NEW MEXICO OIL CONSERVATION DIVISION

Chaco 2306-19E#205H

Re: Request for Administrative Approval of a 200-acre non-standard project area in the Lybrook Gallup Oil Pool (42289) and for non-standard location for the Chaco 2306-19E #205H, API: 30-043-21204

From: Riley, Heather <Heather.Riley@wpxenergy.com>
Sent: Monday, August 11, 2014 2:30 PM
To: McMillan, Michael, EMNRD
Cc: Bassett, Chuck; Richardson, Amy; Felix, Andrea; Granillo, Lacey; Heil, Mark; Higgins, Larry
Subject: RE: Chaco 2306-19E #205H, Chaco 2306-19E #189H, Chaco 2306-19E #188H

Chaco 2306-19E #205H/Plan #3
 Chaco 2306-19E #205H/OH ST-1
 Last SDI Lateral MWD Survey
 Crossed hardline @ 10,705' MD
 Base Perf @ 10,539' MD (500' FEL)
 Projection to TD

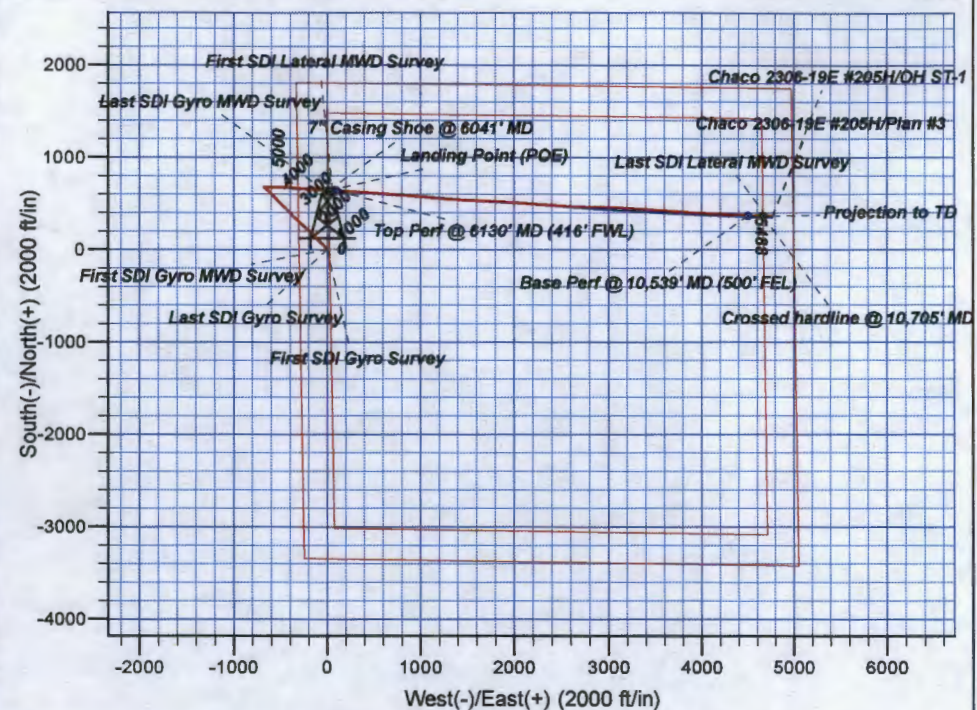
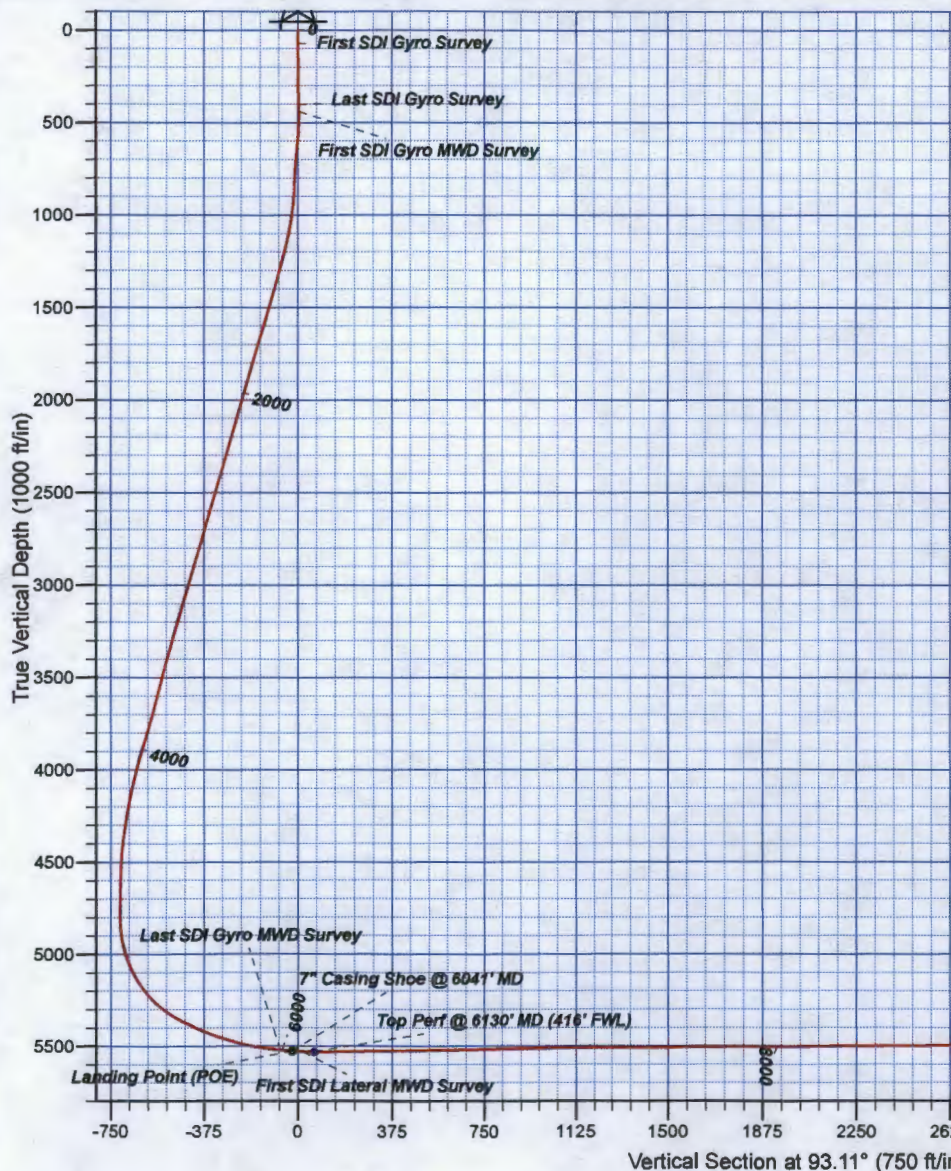
- For the Chaco 2306-19E #205H, I need the distance from the North for the top perf and the bas perf.
- For the Chaco 2306-19E #189H, I need the distance from the South for the top perf, and the distance from the North for the bottom perf.
- For the Chaco 2306-19E #188H, I need the distance from the North for the top and bottom perf

Attached are perforation views showing distances from section lines as outlined in your request below. You should have also received a letter from our Landman under a separate email as requested.
